<b>VISTA DESIGNS</b> <i>Building Designers</i> SUITE 4 201 SEVENOAKS ST QUEENS PARK 6107 TEL. 94584995 FAX. 94584093 © COPYRIGHT	DATE	No.	REVISIONS	TITLE: <b>PROPOSED DEVELOPMENT FOR I &amp; A INVESTMENTS LOT 1 WARRANDYTE DR LOT 143 ELWOOD CRT LOT 2 EDDYSTONE AVE CRAIGIE</b>	DATE:	8-03-05
		20-5-5	VARIOUS AMMENDMENTS AS PER 11-5-5 'DA ASSESS'		SCALE:	1:500
		4-7-5	VARIOUS AMMENDMENTS AS PER 'DA ASSESS' No 2		DRAWN BY:	TM
					DWG. No.:	2475
					SHEET No.:	2 OF 15

**RE: AMENDED PLANS FOR PROPOSED DEVELOPMENT OF 15 SINGLE STOREY GROUPED DWELLINGS AT THE CORNERS OF EDDYSTONE AVENUE, WARRANDYTE DRIVE & ELWOOD COURT, JOONDALUP**

This submission has been prepared on behalf of the land owners I and A Investments Pty Ltd, to address each of the points raised in your correspondences. We seek your support for the proposal and its presentation to the meeting of the Joint Commissioners scheduled for 19th July 2005.

### SHADOW DIAGRAMS

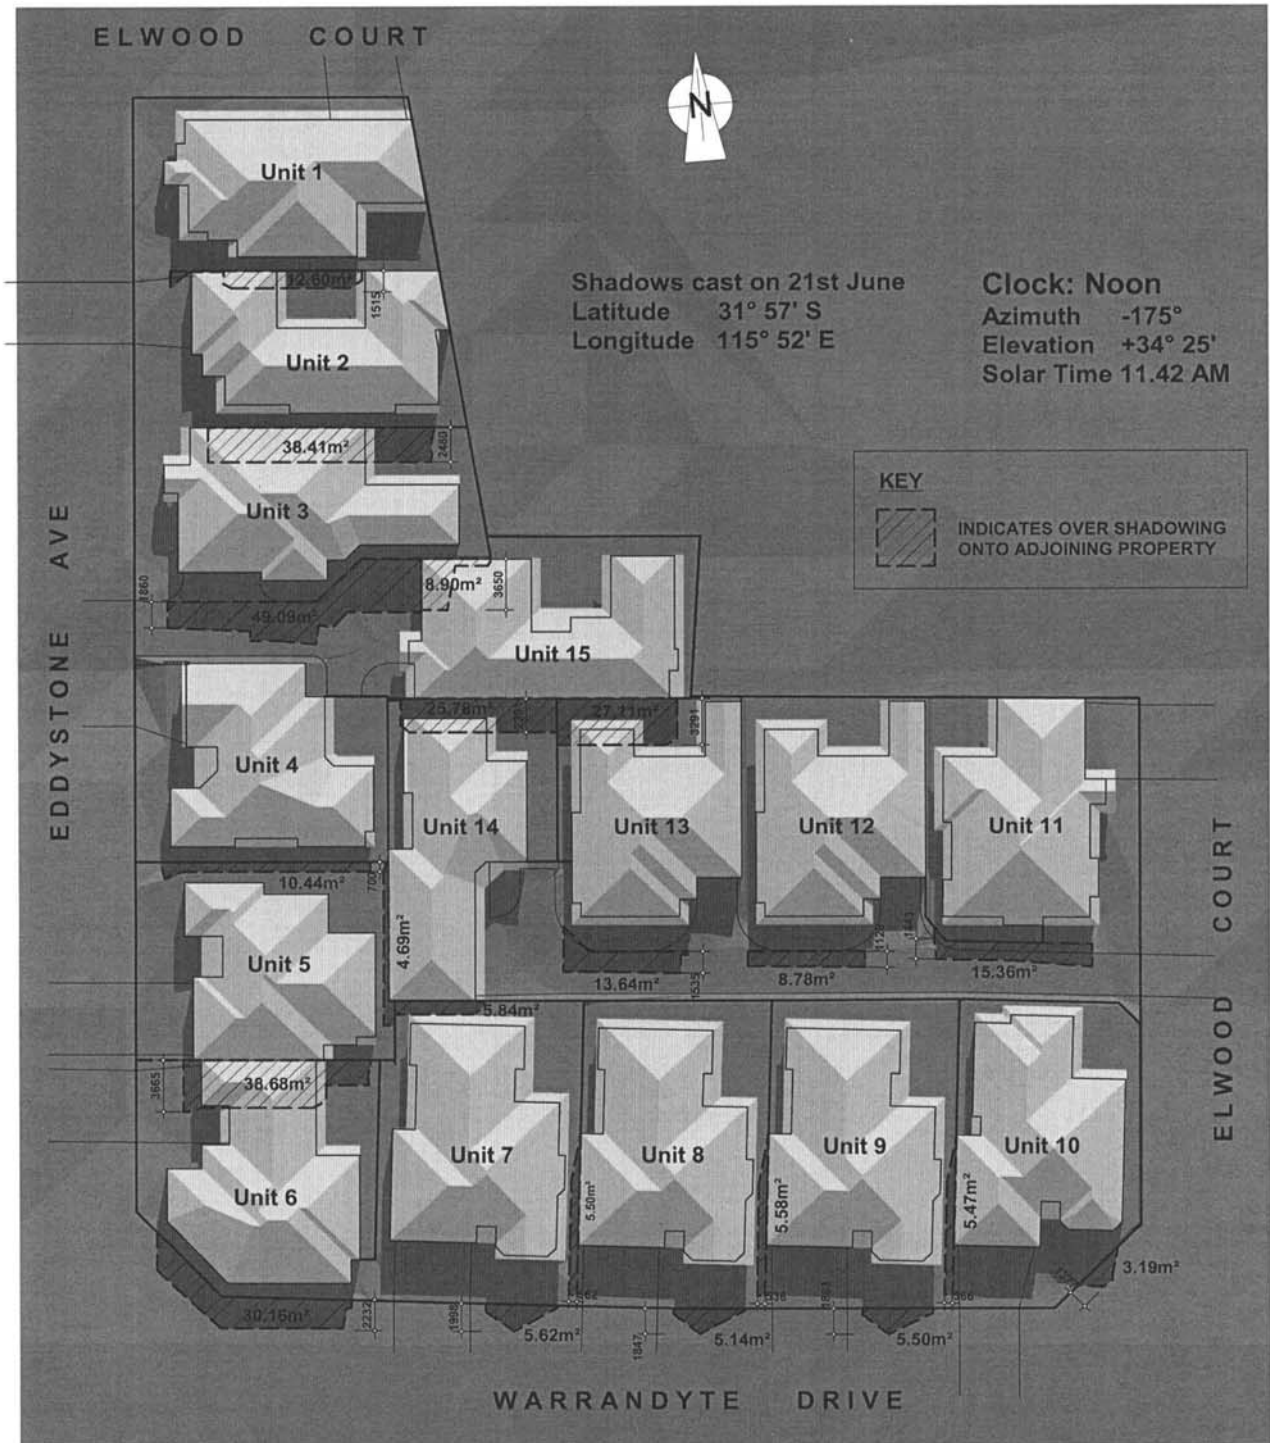
14. *The City has concerns that several of the proposed dwellings may not satisfy clause 3.9.1 of the R-Codes. Each building is to be designed so that its shadow cast at midday, 21 June onto any other adjoining property does not exceed 35% of the site area. You are required to provide shadow diagrams in order to demonstrate compliance with this policy.*

A shadow diagram for each of the 15 dwellings proposed has been provided (see attached plan). Each dwelling is well within the maximum 'shadow' limits permitted for the R40 density code, accordingly the development complies with acceptable development provision 3.9.1 A1 of the RCodes.

**FLOOR PLAN - UNIT 3**

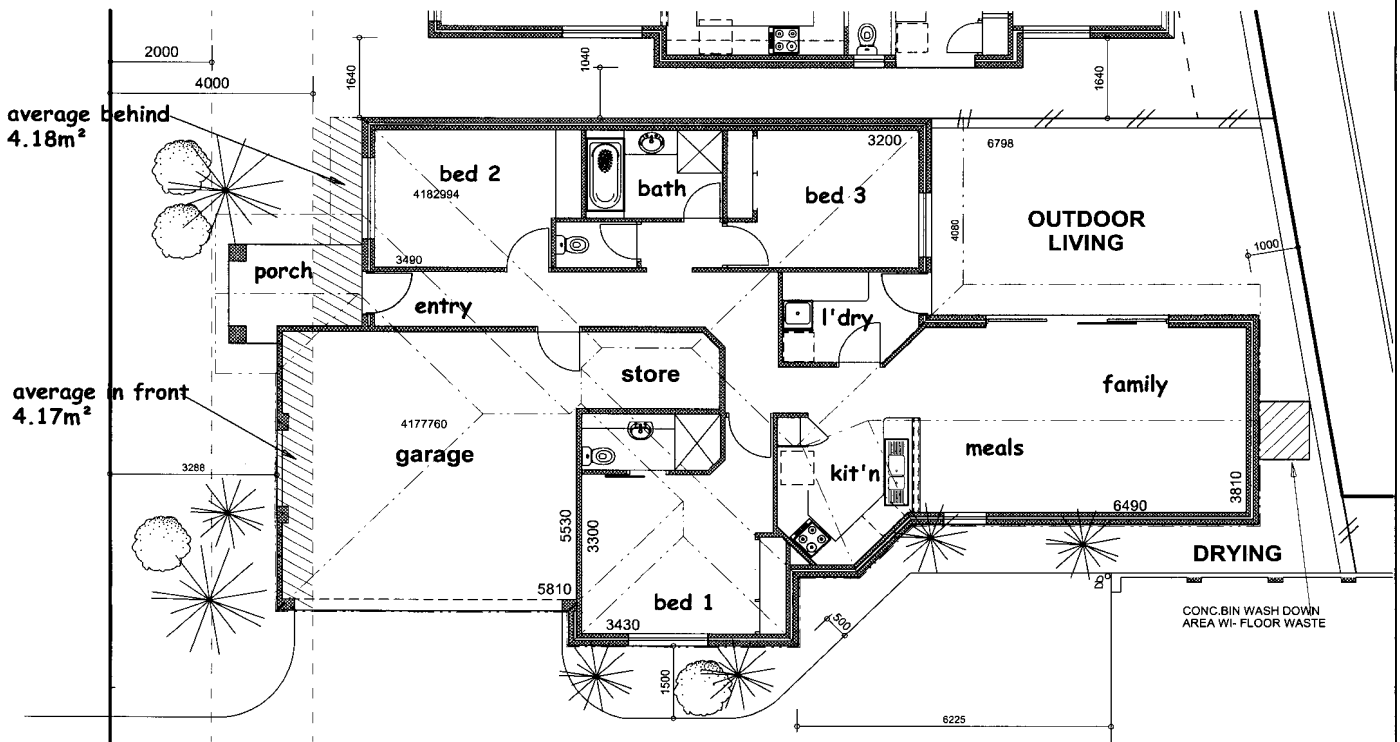
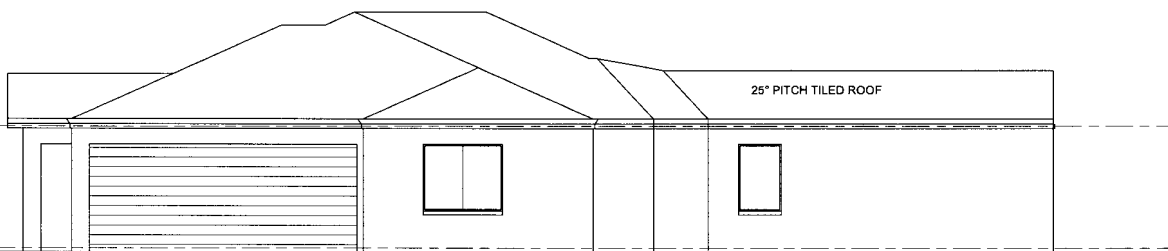
- i. ~~Eastern side setback of 1.004 metres in lieu of 1.5 metres pertaining to Unit 2~~ \*
- ii. ~~Eastern side setback of 1.2 metres in lieu of 1.5 metres pertaining to Unit 3.~~

- (ii) The window previously facing the eastern boundary for the living room for unit 3 has been removed and a blank wall put in its place. Accordingly only a 1.0 metre setback is required to the eastern boundary given that the wall facing this boundary is less than 9 metres in length and has no major openings. The wall therefore complies with the acceptable development provision 3.3.1 A1 (i) of the RCodes.

**FLOOR PLAN - UNIT 4**

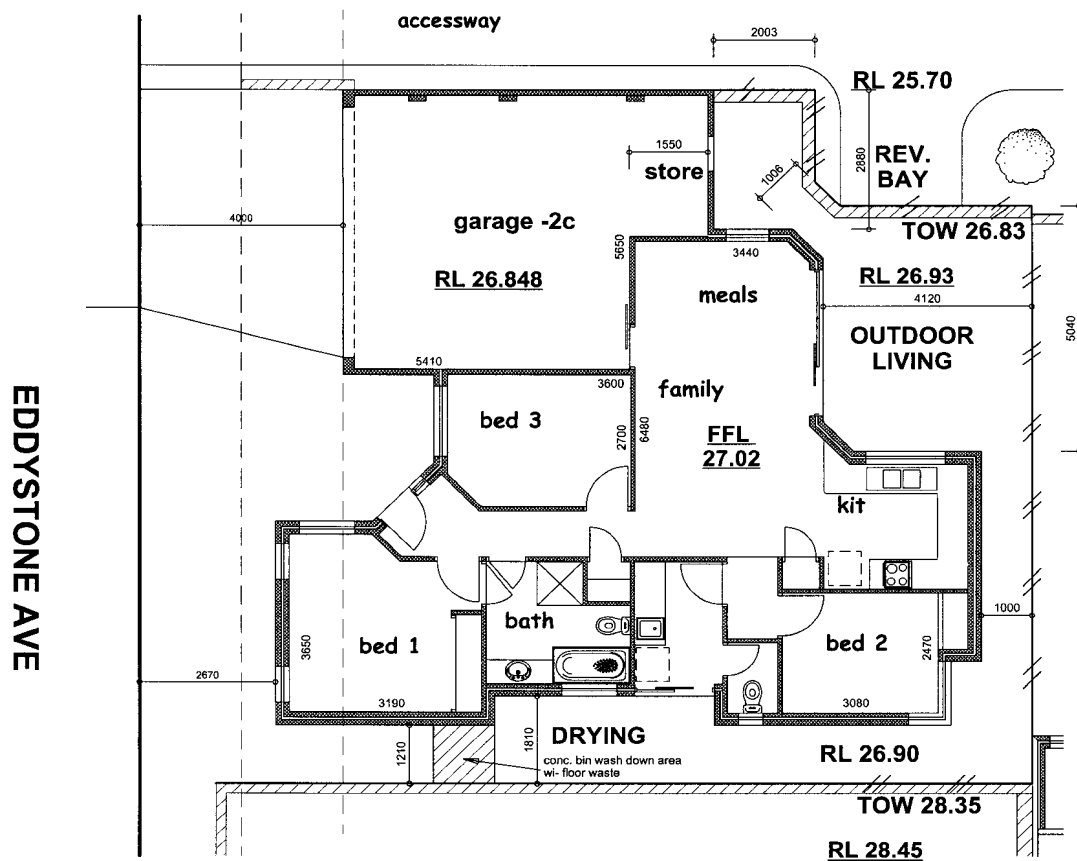
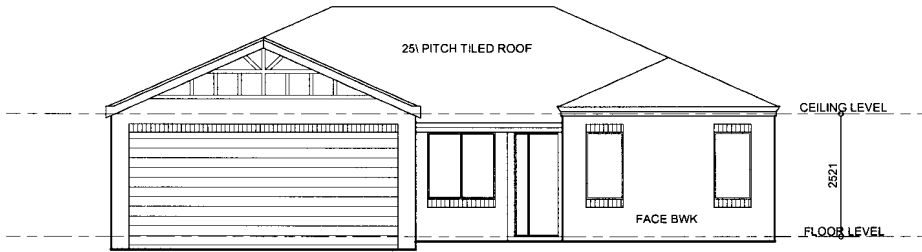
11. *You are required to provide additional elevations of Unit 4, 9, 10 and 14 in order to assess building height and the required setbacks. From the site and floor plans, it cannot be determined whether openings to rooms are major or minor.*

- (c) The front setback of unit 4 has been modified to achieve the required minimum 2.0 metre and average 4.0m setback. The garage has been moved back from a 3.5 metre setback previously to a 4.0 metre setback. Bedroom 1 has also been reduced in size. The unit therefore complies with acceptable development provision 3.2.1 and Table 1 of the RCodes.

**FLOOR PLAN 1 : 100**

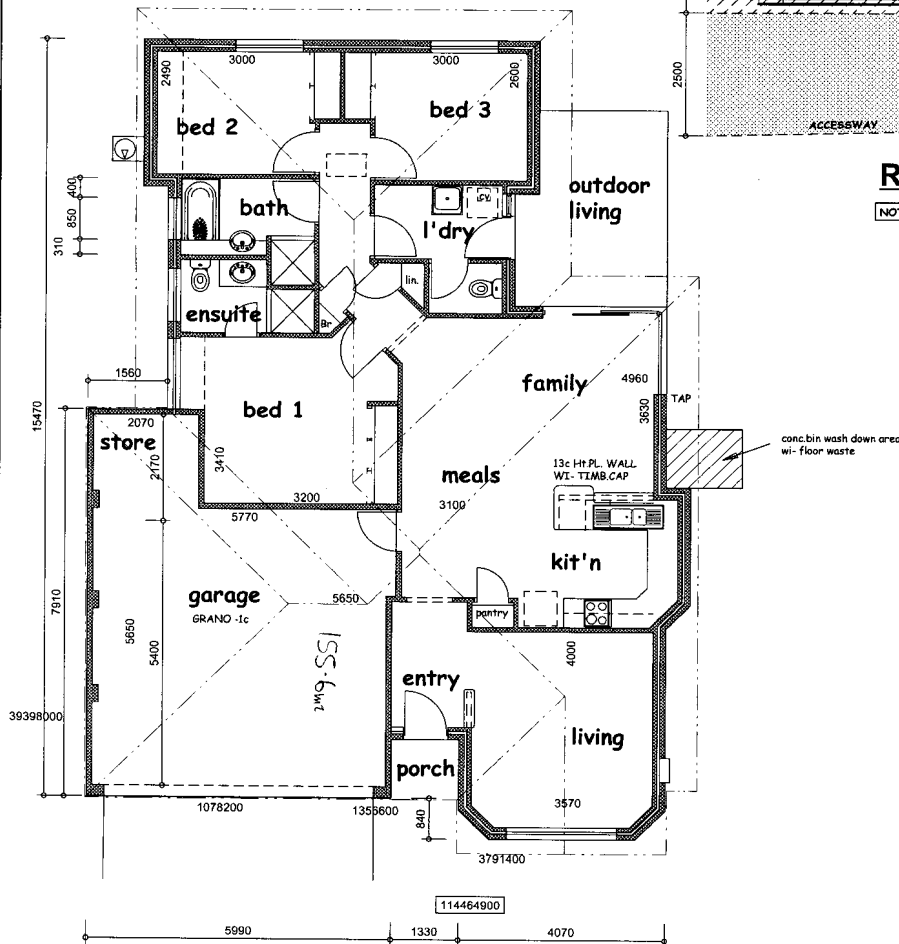
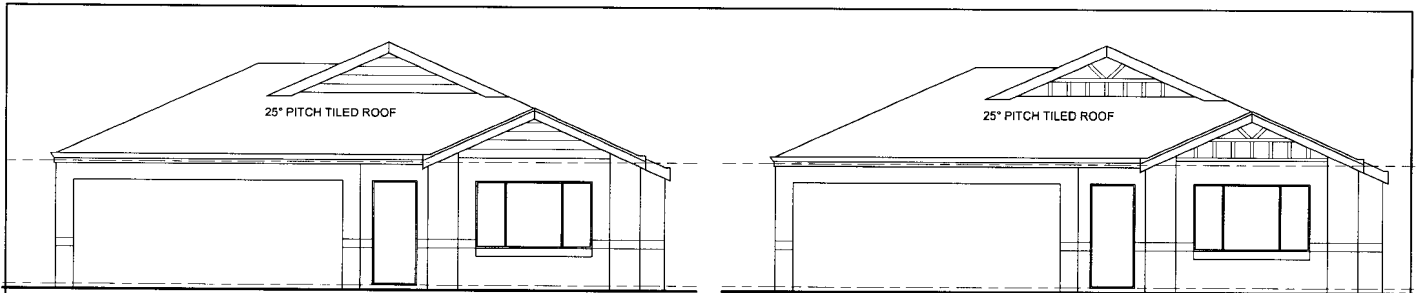
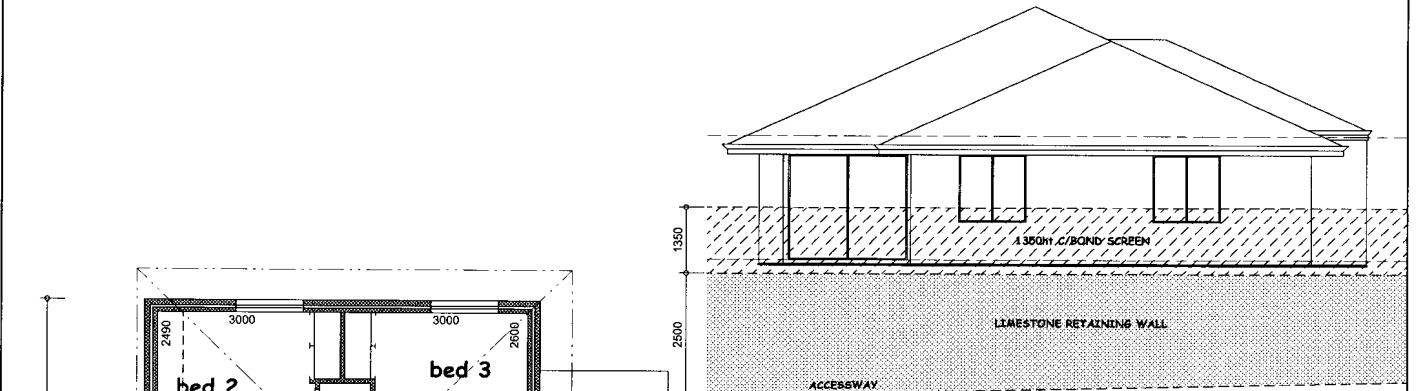
- a. Retaining Wall setback variations between the communal street from Elwood Court and Units 6, 7, 8, 9 and 10:
    - i. ~~Setback of nil in lieu of 1.1 metres pertaining to Unit 6/7;~~

- ii. Setback of nil in lieu of 1.5 metres pertaining to Unit 7;
    - iii. Setback of nil in lieu of 1.5 metres pertaining to Unit 8;
    - iv. Setback of nil in lieu of 1.5 metres pertaining to Unit 9; and

- v. Setback of nil in lieu of 1.5 metres pertaining to Unit 10.

You are required to indicate whether screening is proposed on top of the retaining walls.

- (ii) The retaining wall between unit 7 and the communal street from Elwood Street has been lowered from 2.286 metres in height at its highest point to 1.886 metres in height. This has been achieved by lowering the FFL of unit 7 by 400mm. Although the height of the retaining wall has been reduced it is still above 500mm permitted as of right under the acceptable development provisions of the RCodes.

- (iii) The retaining wall between unit 8 and the communal street from Elwood Street has been lowered from 2.6 metres in height at its highest point to 2.3 metres in height. This has been achieved by lowering the FFL of unit 8 by 400mm and the common access way at this point by 100mm. Although the height of the retaining wall has been reduced it is still above the maximum 500mm that is permitted as of right under the acceptable development provisions of the RCodes.

- (iv) The retaining wall between unit 9 and the communal street from Elwood Street has been lowered from 2.5 metres in height at its highest point to 2.3 metres in height. This has been achieved by lowering the FFL of unit 9 by 400mm and the common access way at this point by 200mm. Although the retaining wall has been reduced in height it is still above the maximum 500mm that is permitted as of right under the acceptable development provisions of the RCodes.

- (v) The retaining wall between unit 10 and the communal street from Elwood Street has been lowered from 2.4 metres in height at its highest point to 2.11 metres in height. This has been achieved by lowering the FFL of unit 10 by 500mm and the common access way at this point by 210mm. Although the retaining wall has been reduced in height it is still above the maximum 500mm that is permitted as of right under the acceptable development provision of the RCodes.

Screening is provided above each of the retaining walls proposed (dividing fence).

**FLOOR PLAN - UNIT 11**

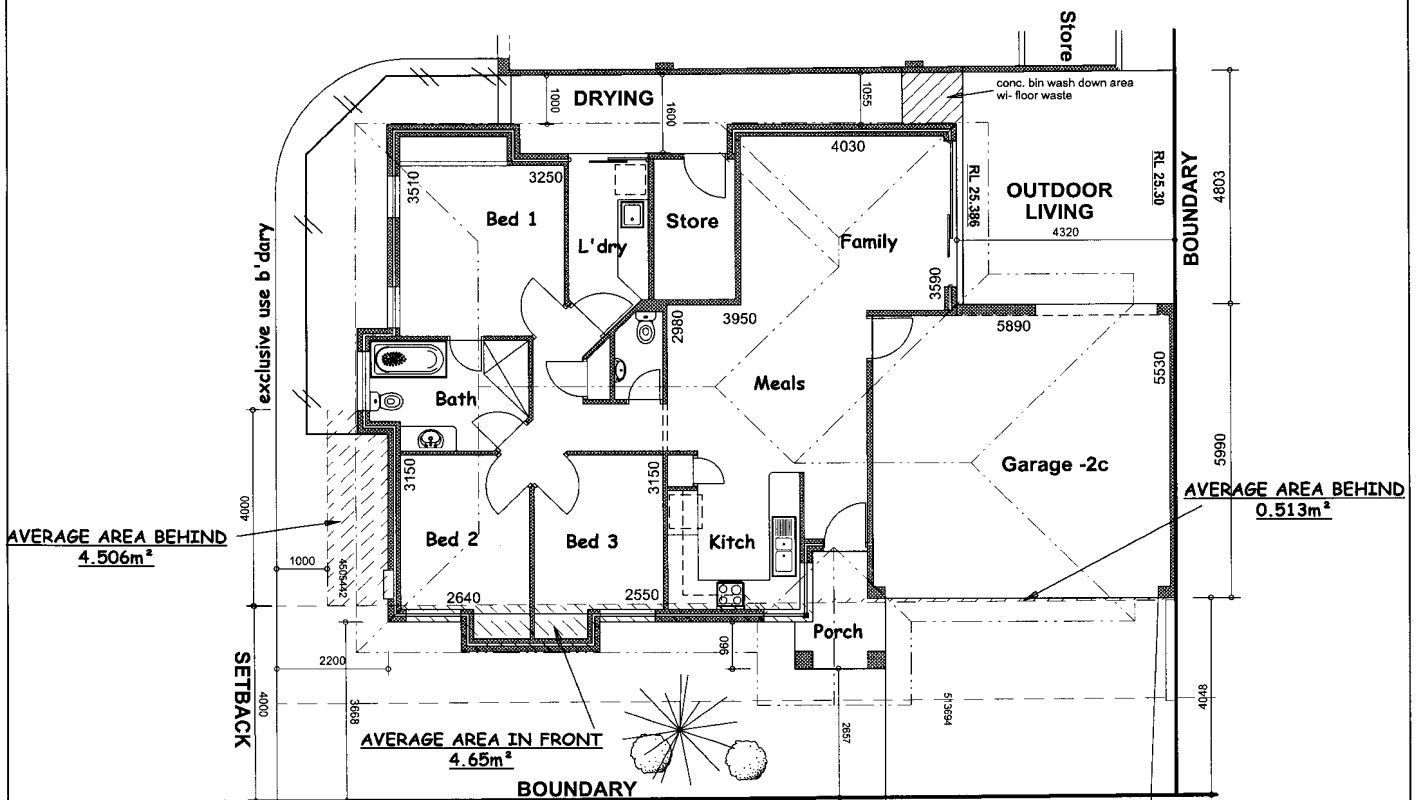
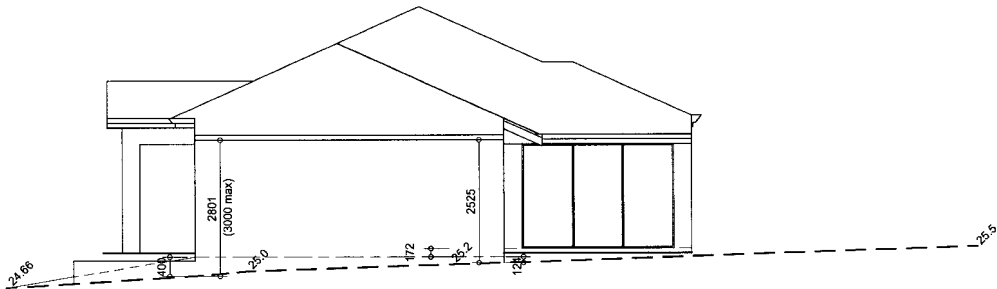
4. The level of the communal street is significantly higher than the finished floor level at Unit 11. You are required to clarify the size and extent of the windows at southern boundary of this unit.

- (g) The front setback of unit 11 has been modified to achieve the required minimum 2.0 metre and average 4.0m setback. The garage, bedroom 2 and kitchen has been setback 3.5 metres previously to 3.83 metres, and 3.24 metres to 3.570 metres, respectively. The portico has also been setback from 2.108 metres previously to 2.438 metres. The compensating area is found along the southern elevation. The unit therefore complies with the acceptable development provision 3.2.1 and Table 1 of the RCodes.
